# CITY OF SAN ANTONIO

Re: The Park at University Hills

MDP # 767

The City Staff Development Review Committee has reviewed The Park at University Hills Development Plan M.D.P. # 767. Please find enclosed a signed copy for your files. Your plan was accepted with conditions as noted.

Attachment A

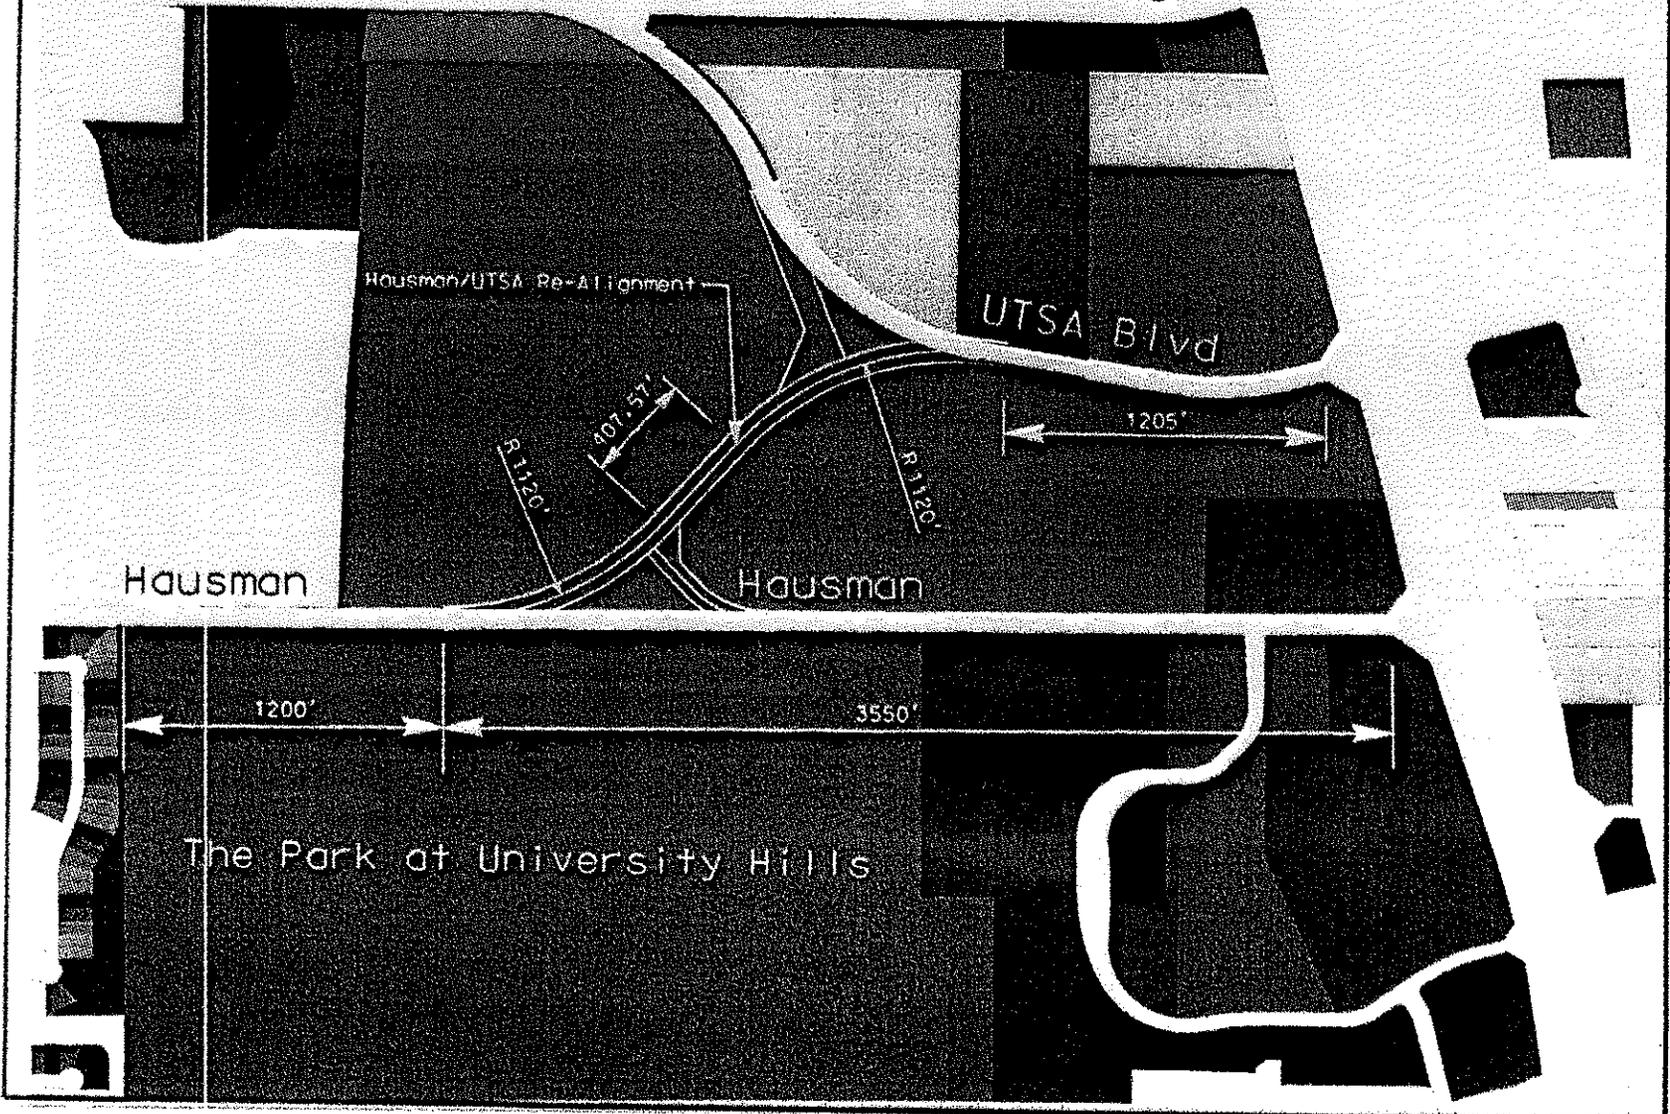
- The Developer shall provide 43 feet of ROW from the centerline of Hausman Road (Secondary Arterial Type A) adjacent to this proposed project from the west corner of the property approximately 1200-feet east for future widening and re-alignment of Hausman Road/UTSA Boulevard (SEE ATTACHMENT A). This will require a property dedication by the developer.
- Construction of an internal collector street system. Collector streets with 70-feet of ROW and 44-feet of pavement shall have no houses fronting.
- All Roadways shall conform to Table 506-1: Functional Classification System Description.
- The developer shall be responsible for upgrading the intersection of Hausman Road and Collector Street (Unit 1) and Hausman Road and Local Type B (Unit 4). This includes sufficient left-turn storage and right-turn deceleration lanes.
